STAFF REPORT

RE: 918 Fort Street-AKA 3.2 acres (project application #TP2022-0019)

FROM: Karen DeMaria, City of Key West Urban Forestry Manager

Photo of tree trunk.

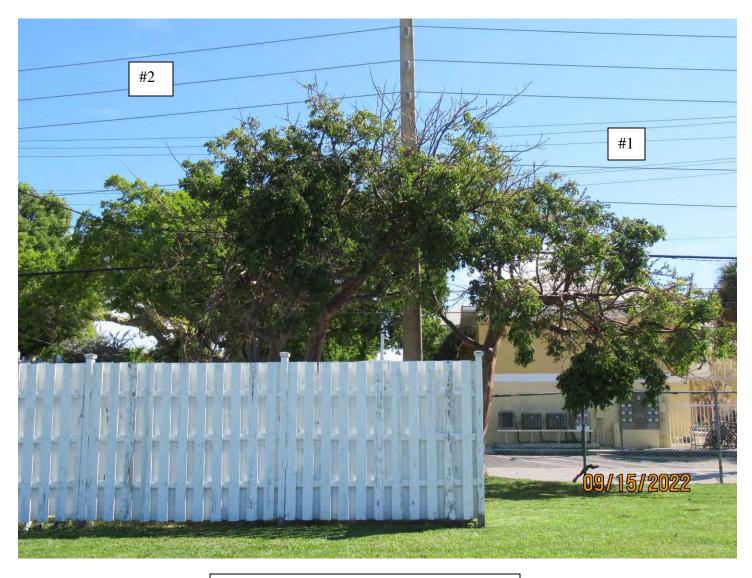
Diameter: 14" Location: 60% (growing under utility lines and close to utility pole, close to sidewalk, very visible tree) Species: 100% (on protected tree list) Condition: 50% (overall condition is fair, poor canopy structure) Total Average Value = 70% Value x Diameter = 9.8 replacement caliper inches

Tree #2

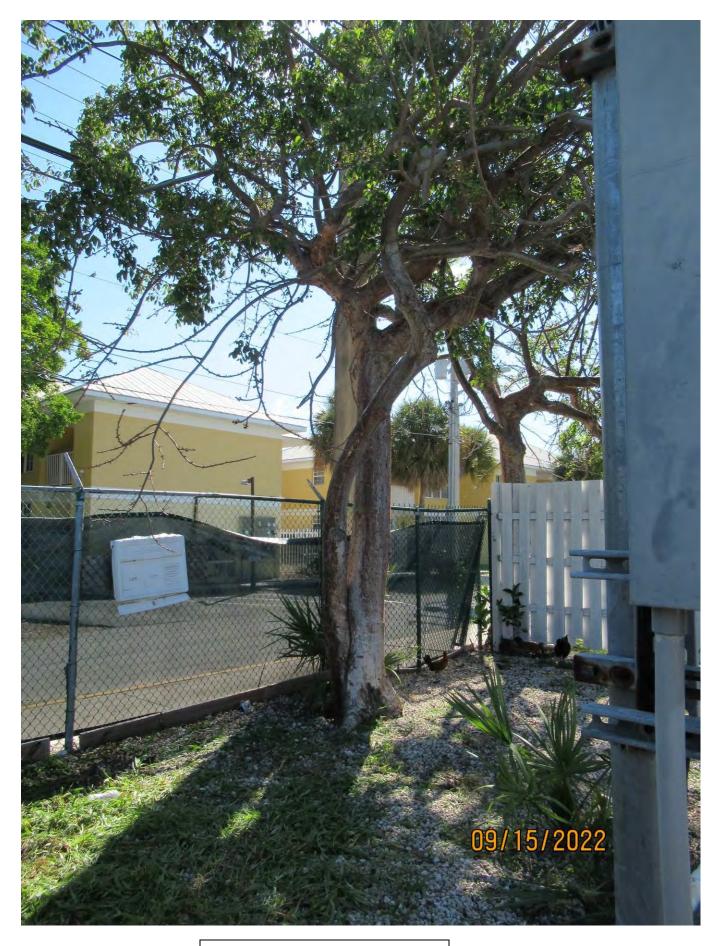
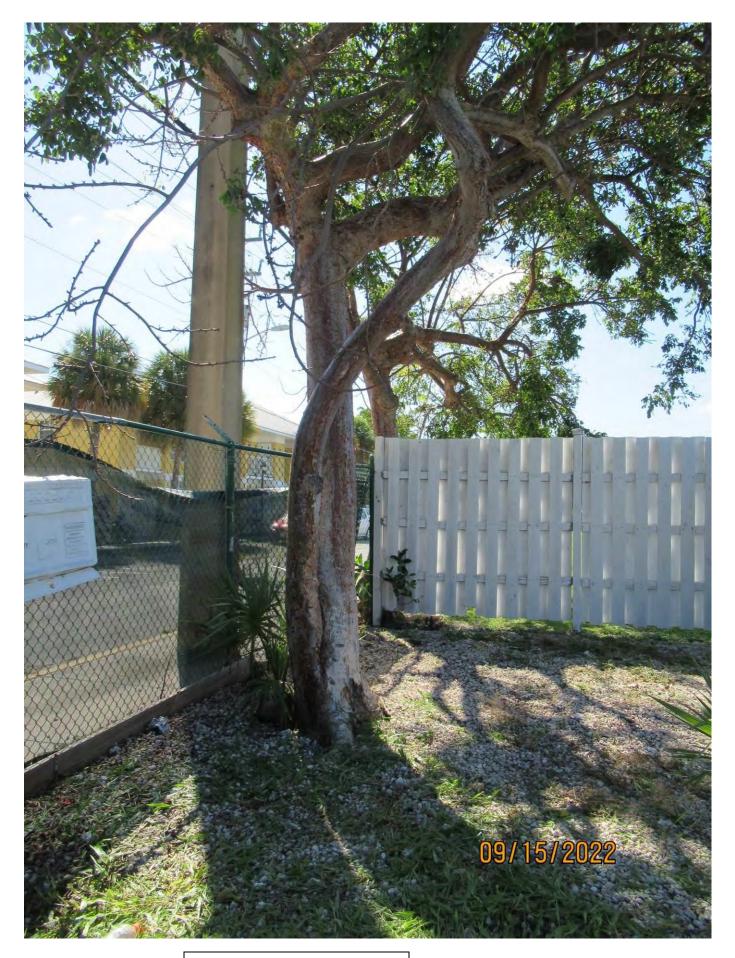
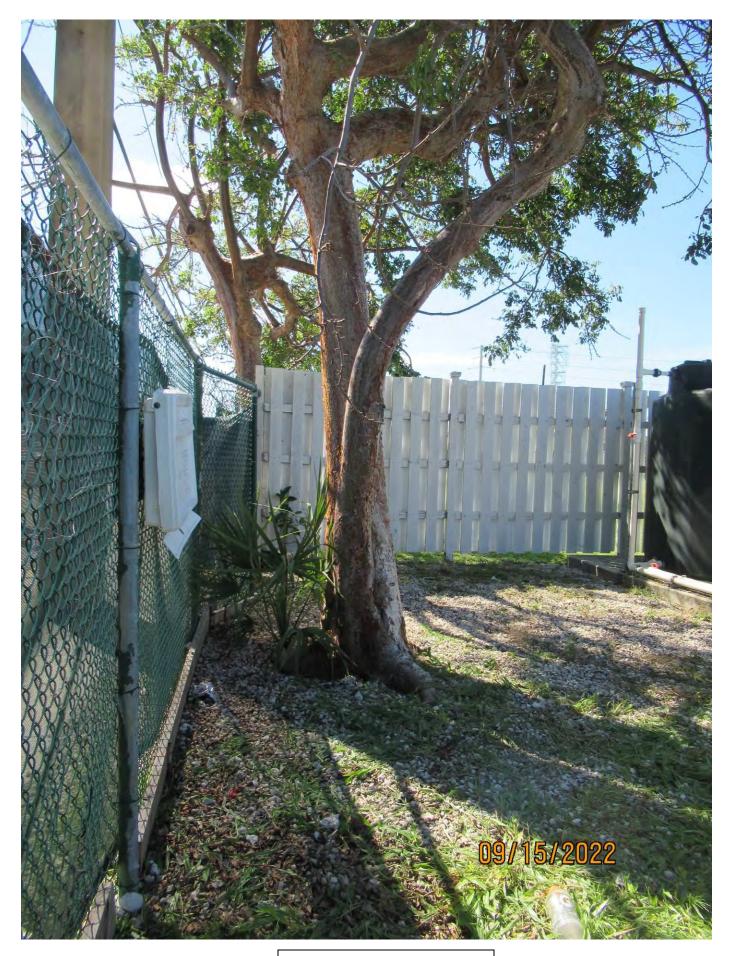
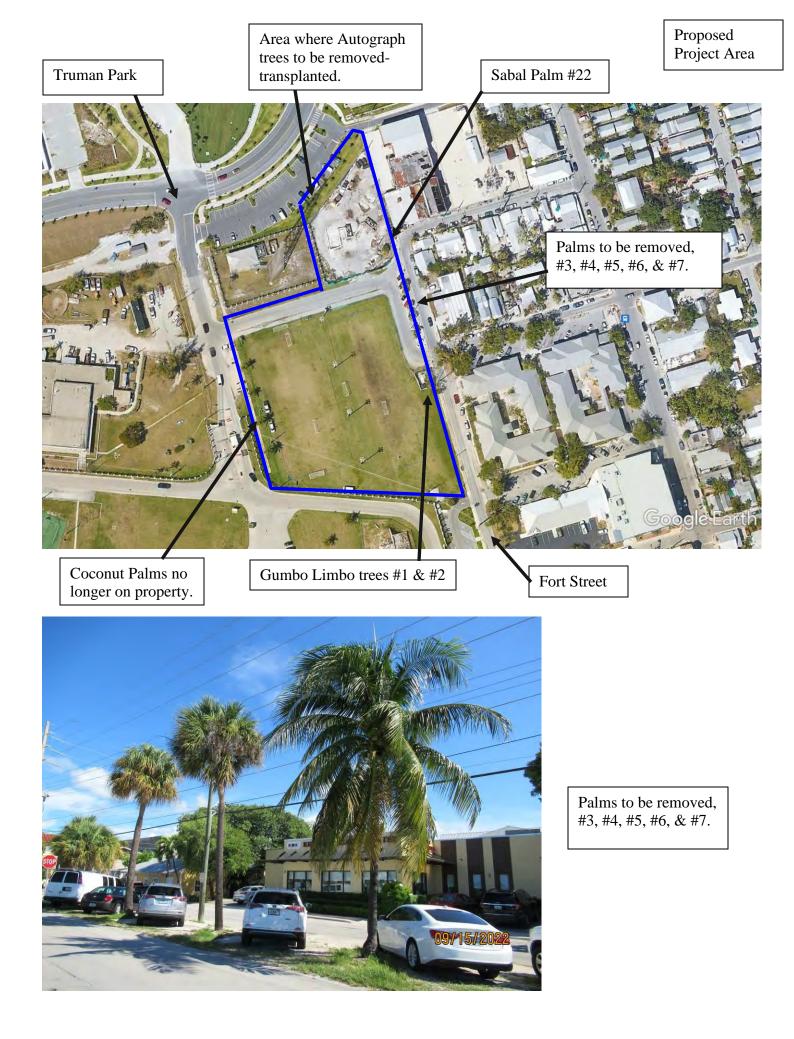
Close up photo of tree trunks. Note the presence of included bark.

Diameter: 15.2" Location: 70% (canopy close to utility lines) Species: 100% (on protected tree list) Condition: 40% (poor canopy structure, two trunks with included bark.) Total Average Value = 70% Value x Diameter = 10.6 replacement caliper inches

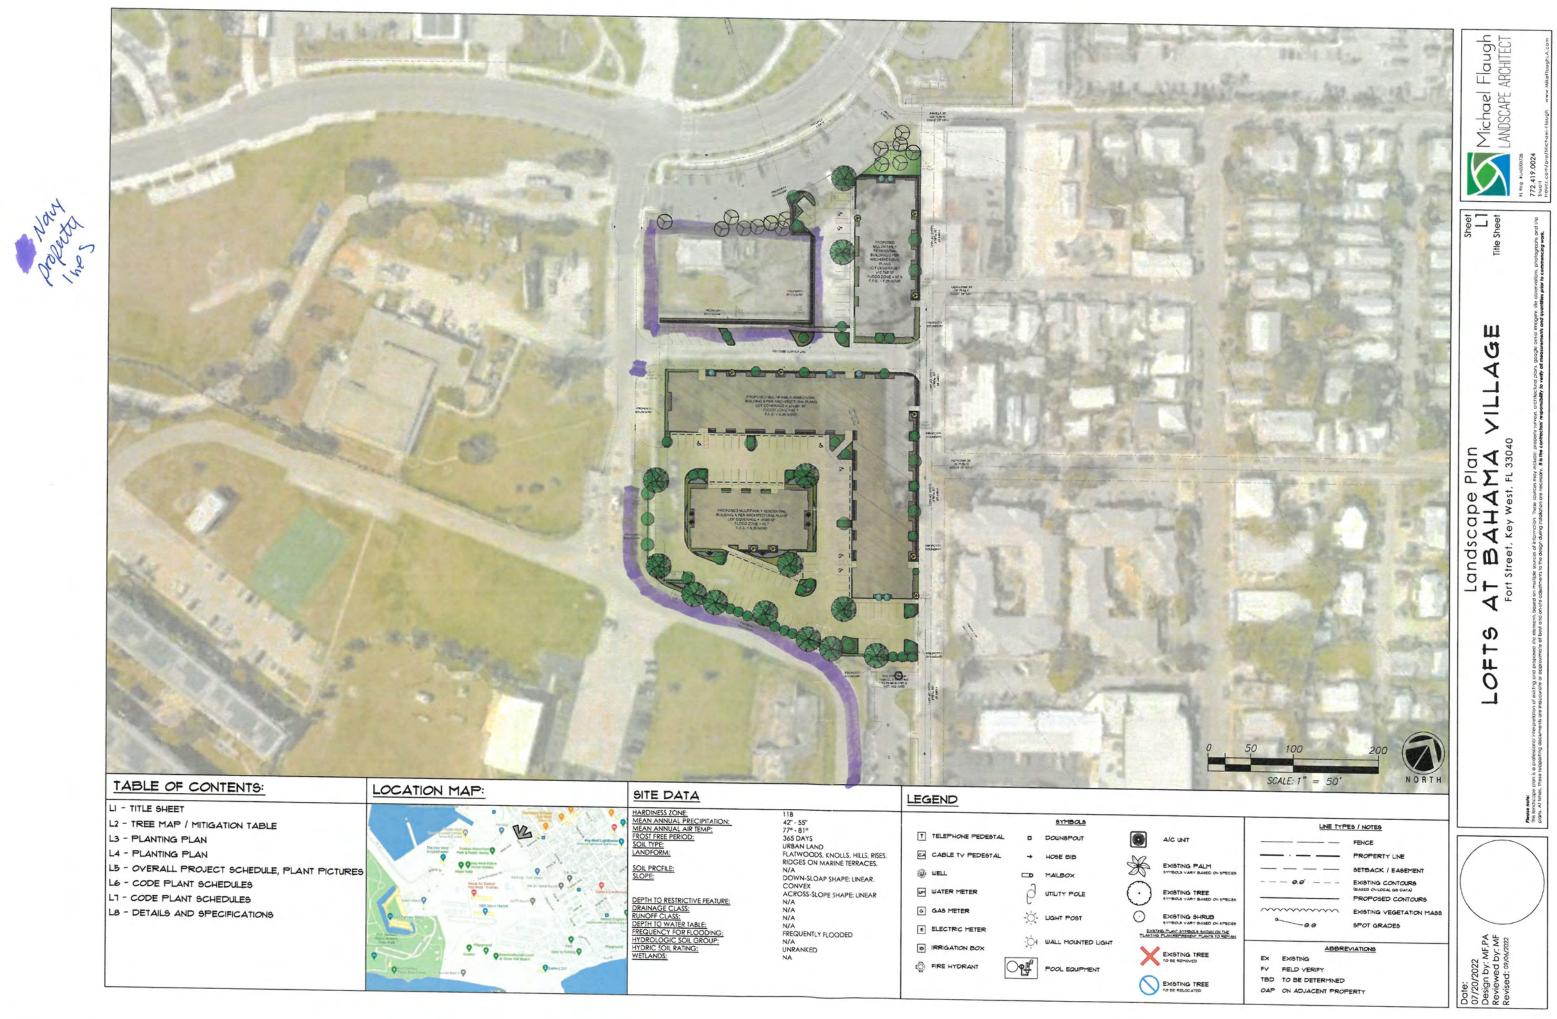
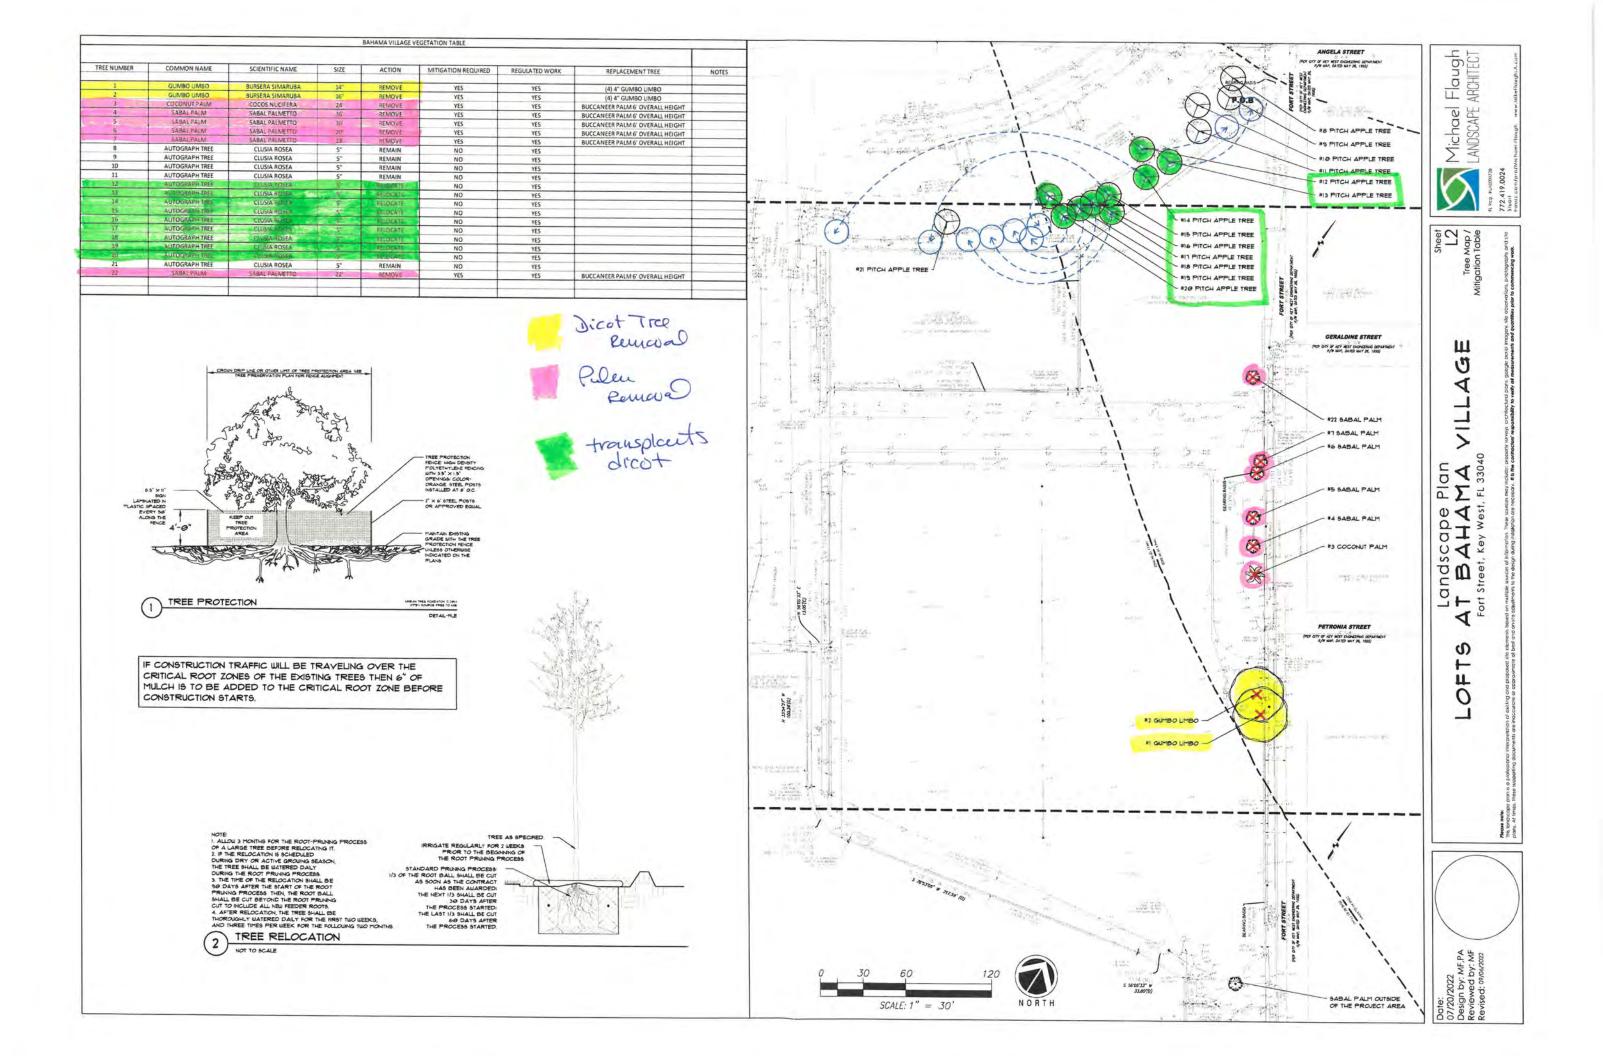
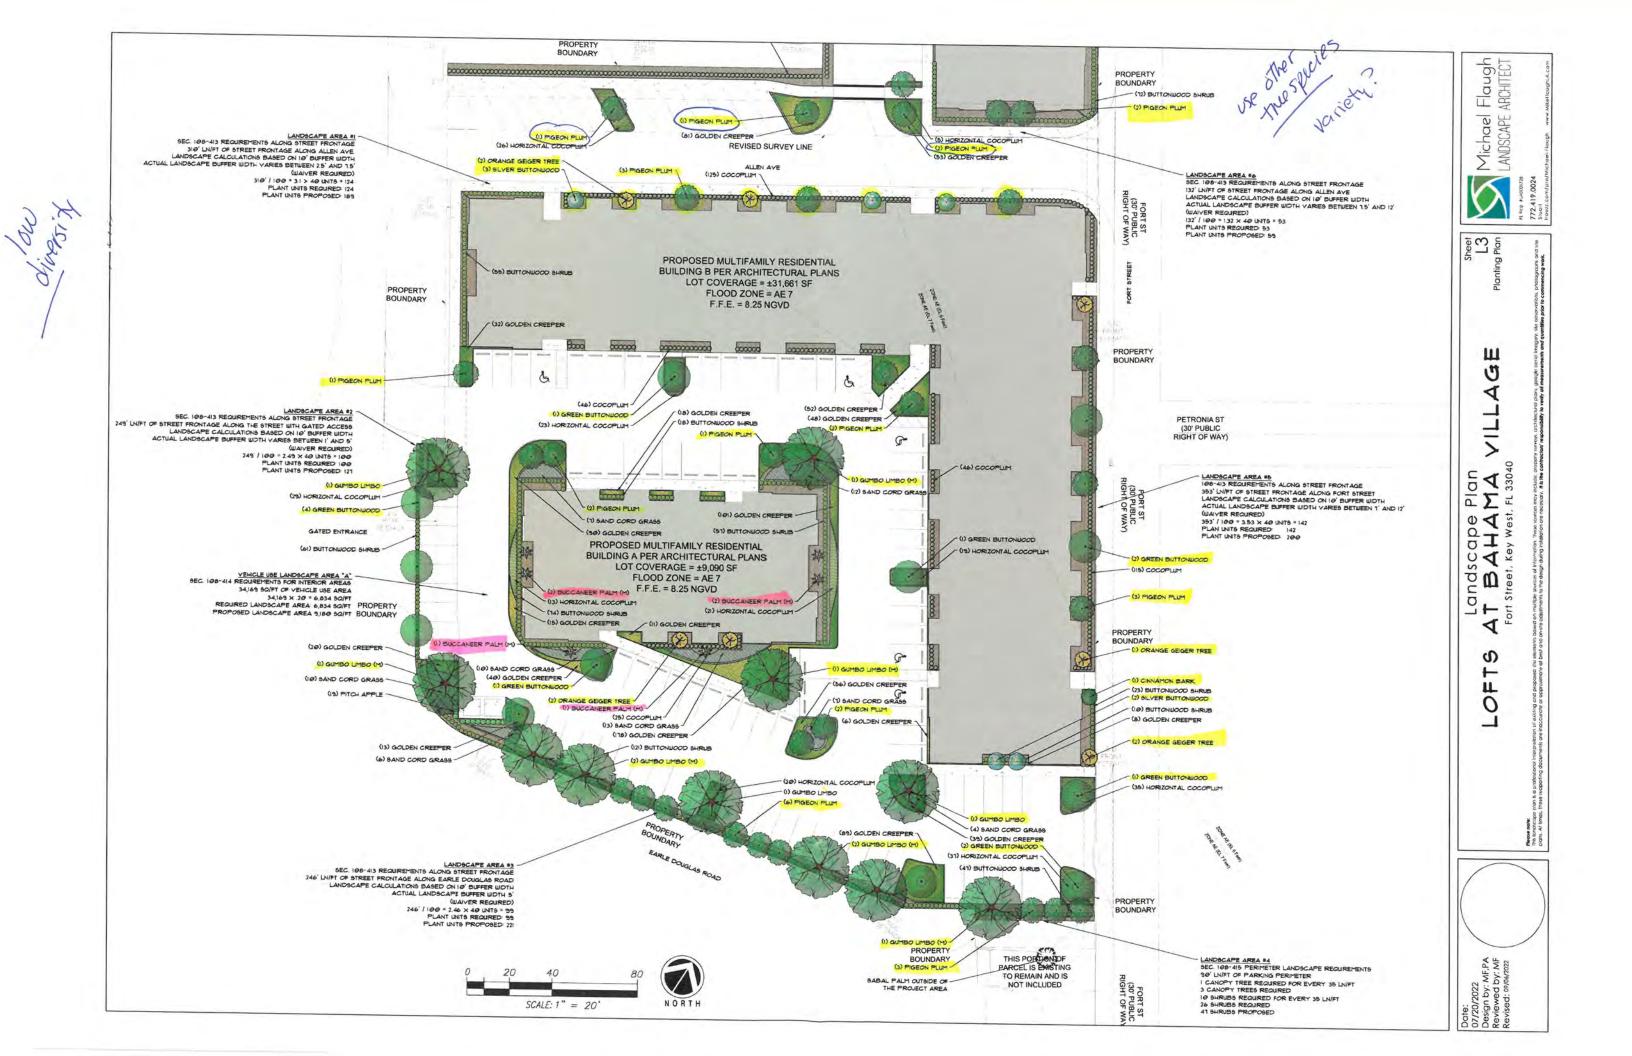
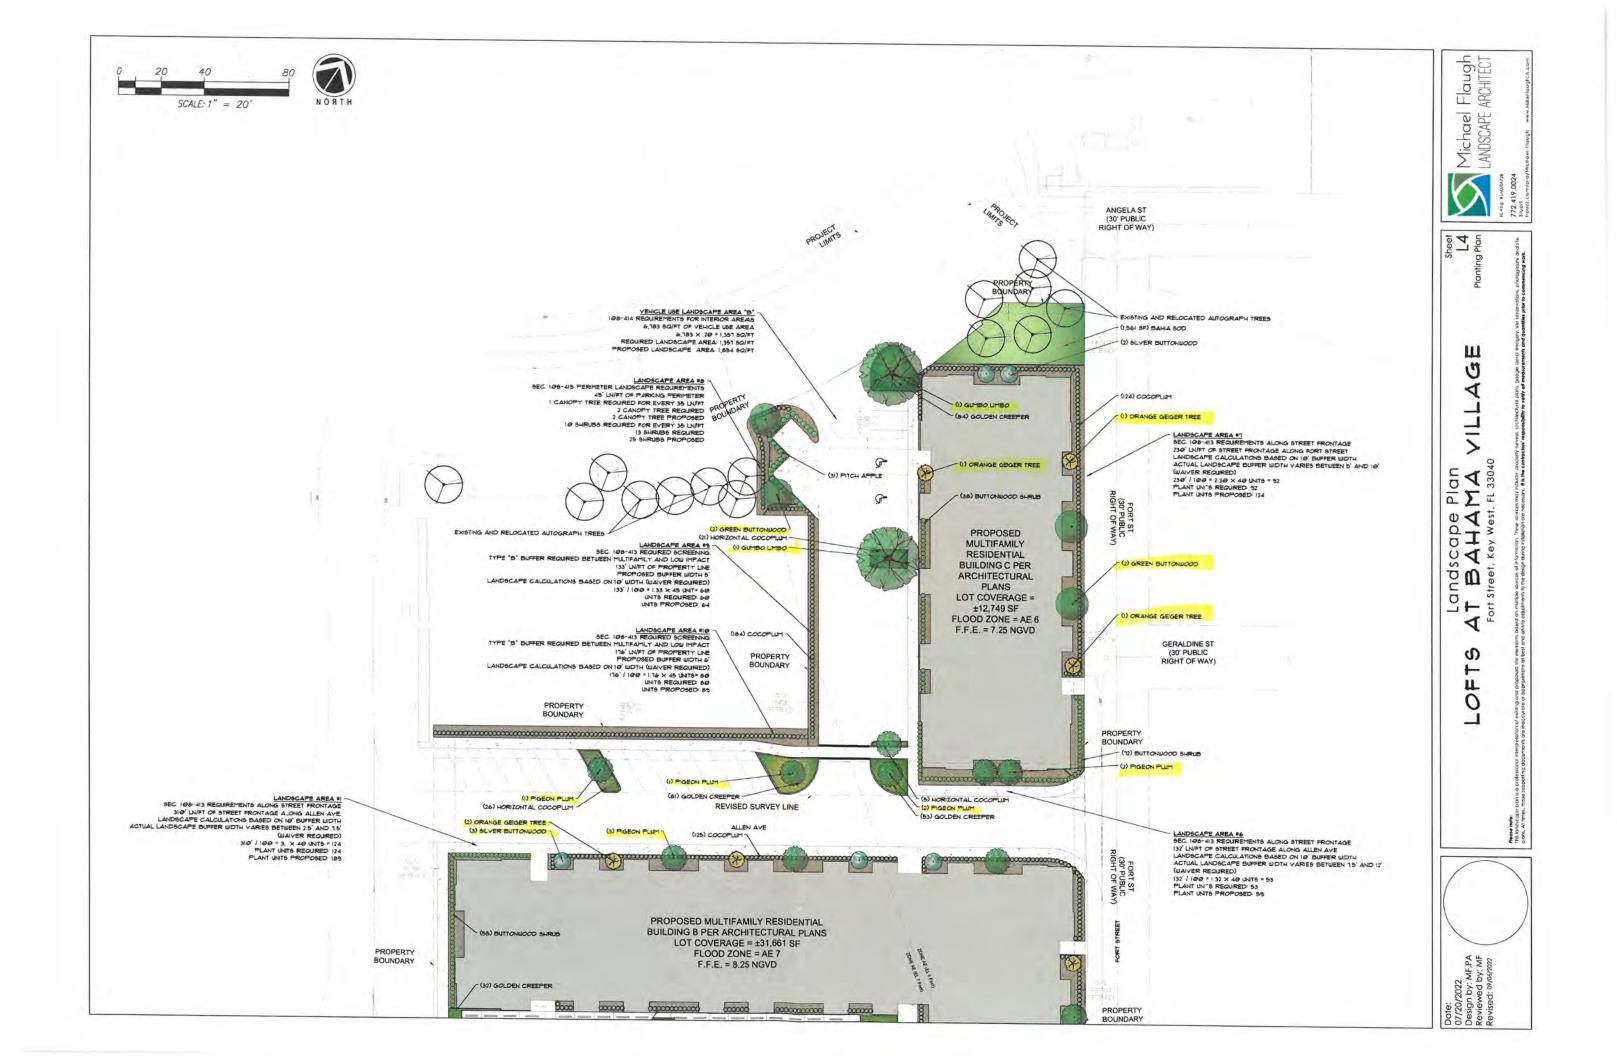
- 1. The relocation of the Autograph trees in the Truman Park parking area for access to proposed development area #1 will need to be coordinated with the Navy and staff. Actual replanting locations are unknown at this time. This work will also require an administrative modification to the Truman Park MDP.

- 2. At least three of the Sabal Palms are eligible for transplanting.
- 3. What is the required Navy buffer from their property line? Based on development requirements with Truman Park, landscaping might not be allowed in certain areas.

- 4. Landscape plan lacks diversity-too many Pigeon plums. Sidewalk and street areas need more canopy type tree species.
- 5. Proposed size of canopy trees in plans is smaller than the ornamental tree sizes. Typical planting of canopy trees in this area should be 65-gallon or a fat 45-gallon sized pot.

- 6. Required mitigation does seem to be included in the landscape plan and the proposed draft plan does include over 70% native vegetation.
